Access Compliance Report

Public Rights-of-Way

(Curb Ramps)

Intersection ID: 50248	Main Street: HANBERRY_BV	Cross Street: DERRYRUSH_DR	Location: SW
ADA ID: D303A6C1ABF0	Ramp Type: PerpDiag	Initial Pass/Fail: Fail	Overall Compliance: No
Severity Score: 43.75			
Codes/Mitigation Info/Possible Solution		Field Measurements/Component Compliance

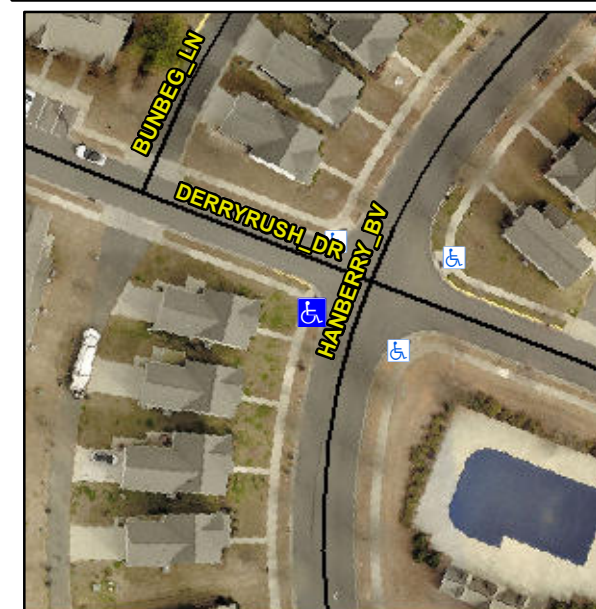
Not Found, R304.5.1, R304.2.2, R304.5.3

Compliance	Description	Data	Compliance	Description	Data
N/A	Ramp Length (in)	65.0	No	Ramp Slope (%)	12.4
No	Ramp Width (in)	33.0	No	Ramp XSlope (%)	3.5
N/A	Flare Type LT	N/A	N/A	Flare Type RT	N/A
N/A	Flare Slope LT (%)	N/A	N/A	Flare Slope RT (%)	N/A
N/A	Flare Traversable LT?	N/A	N/A	Flare Traversable RT?	N/A
N/A	Landing Length (in)	N/A	N/A	DWS Provided?	N/A
N/A	Landing Width (in)	N/A	N/A	DWS Contrast?	N/A
N/A	Landing Slope (%)	N/A	N/A	DWS Length (in)	N/A
N/A	Landing X Slope (%)	N/A	N/A	DWS Full Width?	N/A
N/A	Landing Curb? (Y/N)	N/A	N/A	DWS Offset (in)	N/A
N/A	Shared Landing?	N/A			
N/A	Gutter Ponding?	N/A	N/A	Gutter Slope (%)	N/A
N/A	Gutter Lip Ht (in)	N/A	N/A	Gutter X Slope (%)	N/A
N/A	Painted X Walk1?	No	N/A	Painted X Walk2?	No
	X Walk 1 Direction	To SE		X Walk 2 Direction	To NE
N/A	X Walk 1 Width (in)	N/A	N/A	X Walk 2 Width (in)	N/A
	X Walk 1 Slope (%)	3.0		X Walk 2 Slope (%)	2.9
	X Walk 1 X Slope (%)	1.9		X Walk 2 X Slope (%)	0.3

Remove & Replace Curb Ramp With Two New Directional Ramps or Equivalent.
